## TECHNICAL SERVICE BULLETIN

## British Motor Holdings (U.S.A.) Inc.

Re: Intermittent Operation of Windshield Wipers MG 1275 Sedan

Uncovered Lucar Connectors

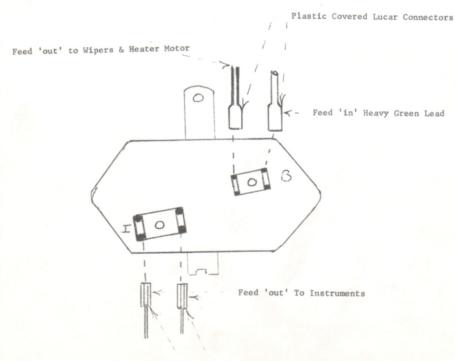
The above problem has been traced to incorrect wiring of the voltage stablizer mounted behind the instrument panel.

Ensure that the heavy green feed lead and the two feed out leads to the wipers and heater motor are connected to the "B" terminal on the stablizer. You will note both these leads have lucar plastic covers over the connectors.
